Statement of Response

Proposed Strategic
Housing Development at
Bóthar an Chóiste,
Castlegar, Galway

Document Title: **Statement of Response**

Figure 1: Fig 11.6 Lands to the North of Bothar na Chóiste with the subject site outlined in blue

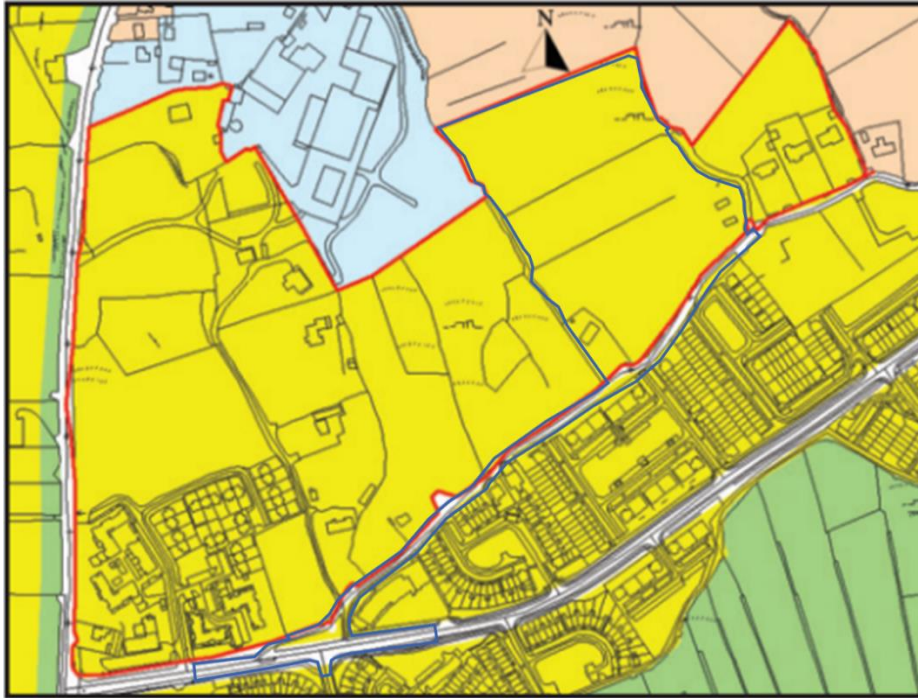
A site-specific objective for the lands North of Bothar na Chóiste is provided within the Galway City Development Plan 2017-2023 under Fig. 11.6. This objective provides a requirement “*for road improvements capable of accommodating future developments shall be incorporated into any development proposals*”. The area relating to this site-specific objective is located primarily to the west of the subject site, as illustrated in **Figure 1** below. It is therefore considered that the proposed road upgrade has successfully addressed the site-specific objective within the GCDP, with the exception of a small section of the road to the east of the subject site as illustrated in **Figure 1** below.

Figure 2 – Specific Objective Fig. 11.6 North of Bóthar na Cóiste

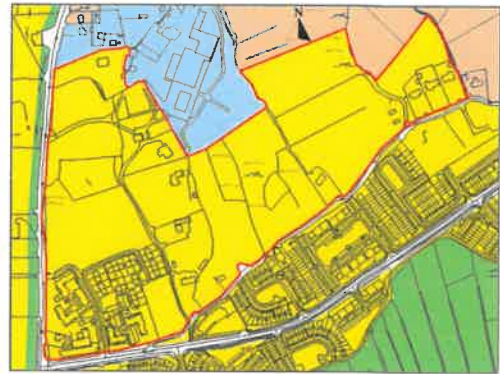
A number of lands zoned R residential in the city have the specific development objectives regarding design, environmental requirements and traffic safety. The subject site is part the land parcel subject to specific development objective Fig. 11.6 North of Bóthar na Cóiste which specifies the following requirements;

- Layout of residential development and boundary treatment shall have regard to the protected views from the Headford Road.
- Any development on these lands shall include for retention of the water body and incorporation of this feature into the development as an ecological amenity in addition to any open space requirements.
- Requirements for road improvements capable of accommodating future developments shall be incorporated into any development proposals.
